Product Change Notification

■Product list PCN2023-03_Crimping manual tool specification change

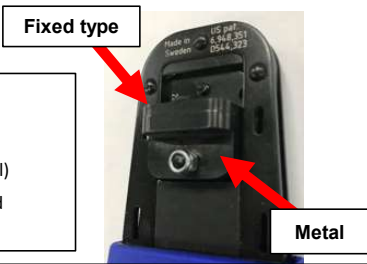
【Changes】 <ul style="list-style-type: none"> Terminal holder shape Material (from resin to metal) From movable holder to fixed holder 	
【Terminal holder: Current product】 	【Terminal holder: Improved product】

- To stabilize crimp quality, the accuracy and strength of terminal holders have been improved.
- In case you already have the subject tool and use it under the following harness conditions, we will replace the tool in free of charge.
We apologize for the inconvenience, but please contact our sales representative.
- When purchasing newly, please purchase the improved product with more stable quality (price will be changed).
